Project	IEEE 802.16 Broadband Wireless Access Working Group < http://ieee802.org/16 >	
Title	The Improvement of Scanning Method Using Preambles in IEEE 802.16e	
Date Submitted	2004-07-07	
Source(s)	<p>Min-Sung Kim, Jeong-Hwi Kim, Seong-Choon Lee KT 17 Woomyeon-dong, Seocho-gu, Seoul, 137-792, Korea</p> <p>Sang-Yun Han, Jinyong Chung, Jae-Hak(Steve) Lee SOLiD Tech., Inc. 78 Garak-dong, Songpa-gu, Seoul, 138-803, Korea</p>	<p>Voice: +82-2-526-6109 Fax: +82-2-526-5200 mailto:cyberk@kt.co.kr</p> <p>Voice: +82-2-2142-3881 Fax: +82-2-2142-3999 mailto:syhan@st.co.kr</p>
Re:	IEEE P802.16e/D3 Letter Ballot	
Abstract	This document suggests the improvement of scanning method using preambles from BSs.	
Purpose	The document is contributed to support certain comment on IEEE P802.16e/D3 Letter Ballot.	
Notice	This document has been prepared to assist IEEE 802.16. It is offered as a basis for discussion and is not binding on the contributing individual(s) or organization(s). The material in this document is subject to change in form and content after further study. The contributor(s) reserve(s) the right to add, amend or withdraw material contained herein.

The Improvement of Scanning Method Using

Figure E.1—Example BS advertisement and scanning (without association) by MSS request

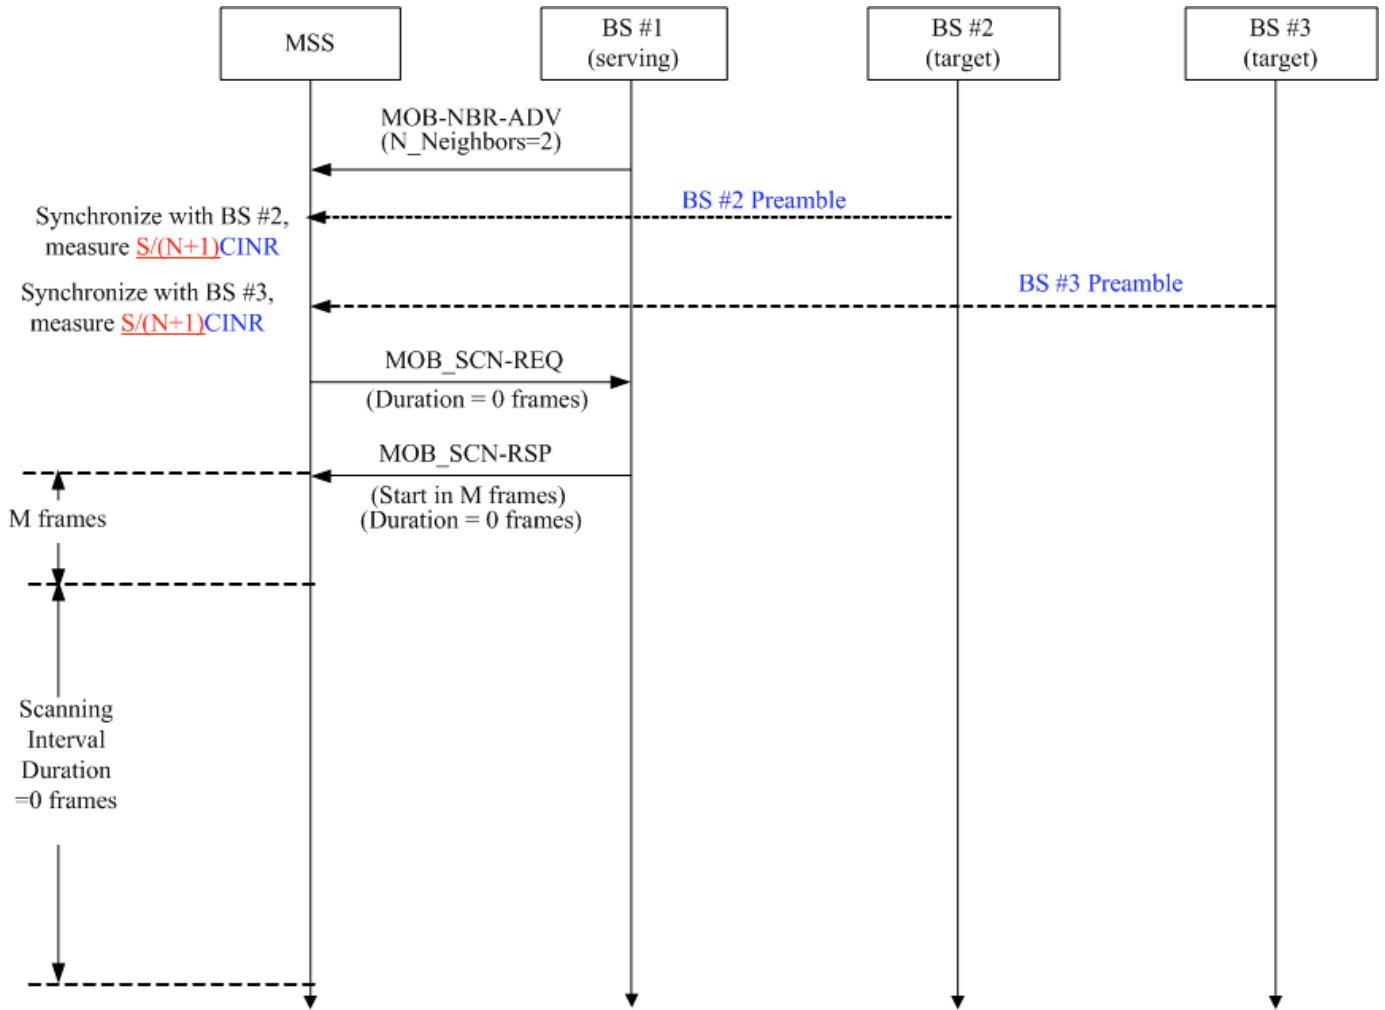
In this contribution, all BSs should be time synchronized to a common timing signal such as GPS. MSS cannot scan several target BSs simultaneously. Therefore, the scanning is executed in a frame for several neighbor BSs in the case of no association. After completing scanning, MSS notify the result to serving BS by MOB-SCN-REQ message. Then, the serving BS respond with MOB-SCN-RSP message. In this case, the value of duration field shall be "0."

Figure E.2—Example BS advertisement and scanning (with association) by MSS request

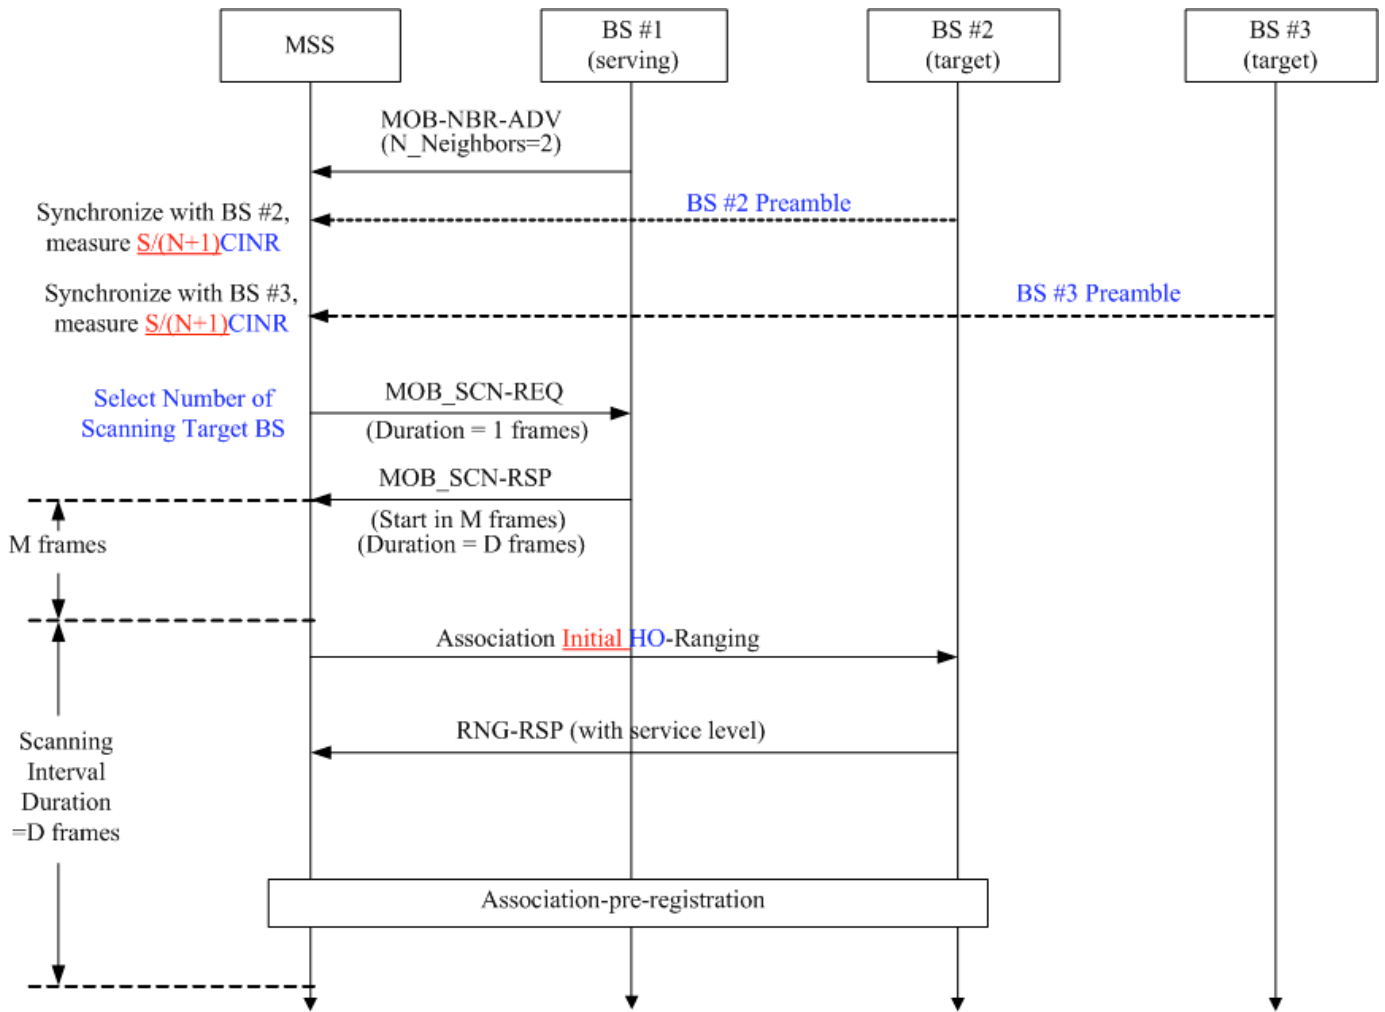
The MSS which tries to associate with neighbor BSs requests the allocation of scan duration to the serving BS by sending MOB-SCN-REQ message which has the preferred scan duration(0) in the duration field. Then, the serving BS assigns the scan duration by MOB-SCN-RSP message. After that, the MSS execute the scan and association process.

Figure E.3—Example BS advertisement and scanning (without association) by BS request

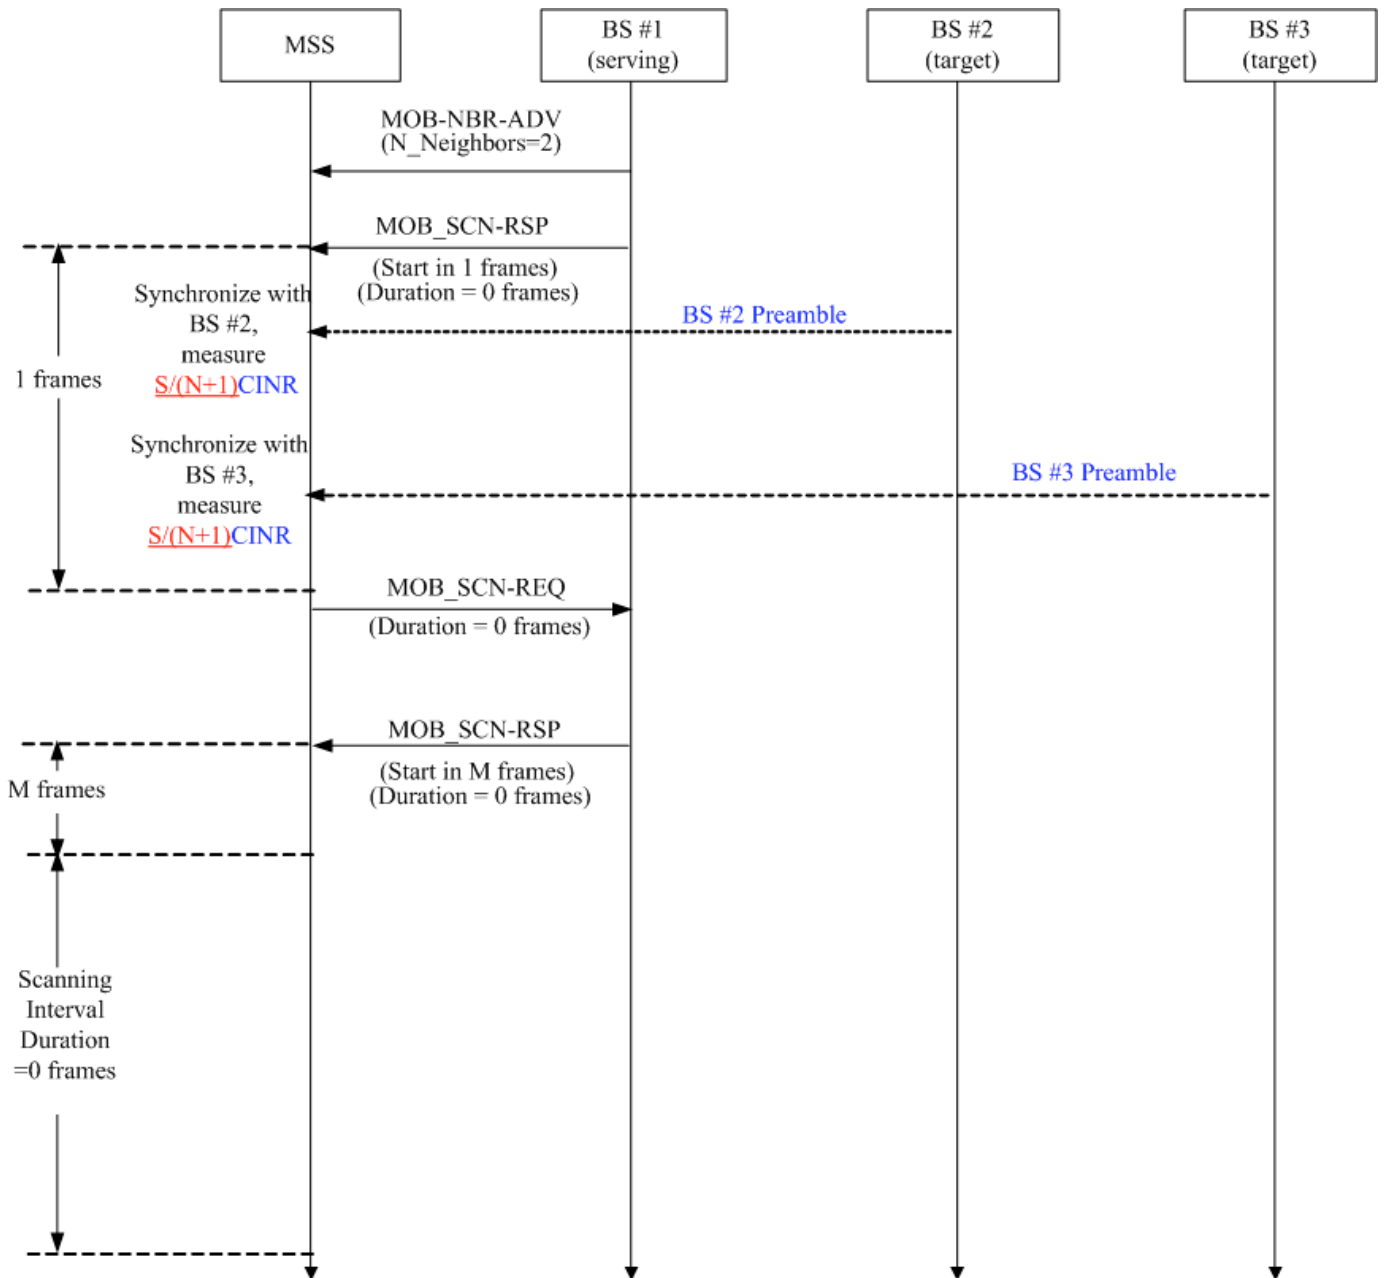
When serving BS requests scanning, duration field shall have the value of "0" in the case of no association and have some value(0) in the case of association.
